FDOT INDEX #200/211 TYPE 5 CURB INLET # S-203

FDOT 434986-1-52-01

STRAIGHT AHEAD CONSTRUCTION

FORTERRA | PIPE & PRECAST

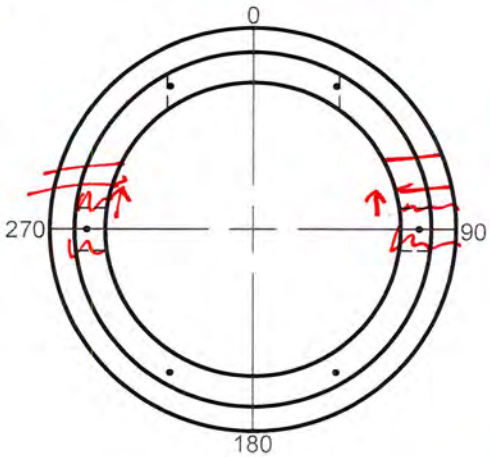
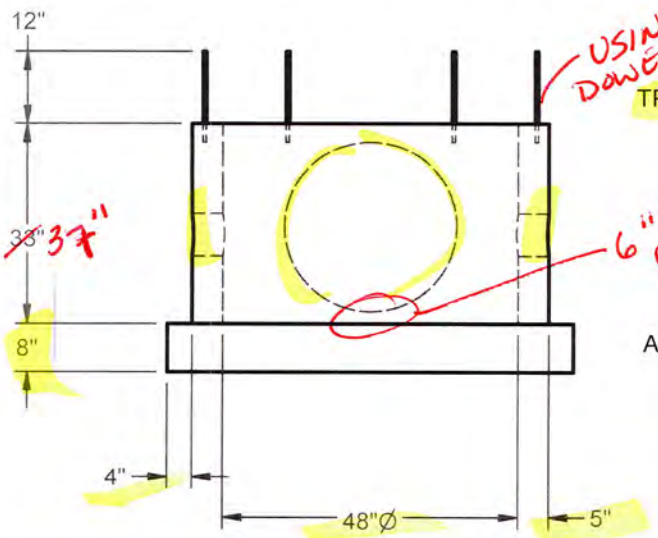
DUE TO NOT HAVING 6" OF CONCRETE ABOVE THE HOLE OPENINGS IN WALL, FDOT WILL REQUIRE THIS SHOP DRAWING TO BE APPROVED BY THE EOR PRIOR TO MANUFACTURE.

ITB = ~~157.35~~

APTB = ~~2.75~~ 3.09

PC #	DEG DIR	PIPE SIZE	PIPE INVERT	HOLE SIZE	BOOT TYPE	HOLE INVERT	HOLE RAISE
1	0	18 RCP	157.93	28	NONE	157.51	~~2"~~ 6"
1	90	4 PVC	158.40	7	NONE	158.28	~~11"~~ 15"
1	270	4 PVC	158.40	7	NONE	158.28	~~11"~~ 15"

PC #	WEIGHT	PIECE DESCRIPTION	PRODUCT CODE
		PER INDEX 201 SHEET 3 OF 5, INCREASING THE UP ELEVATION TO 6" (HOLE RISE) ALLOWS THE CONCRETE ABOVE THE HOLE OPENING TO BE ZERO, USENG DOWEL JOINTS.	
1	4449	048Dia x 05Wall x 033H, MonoBaseExt	SR048B05M036X
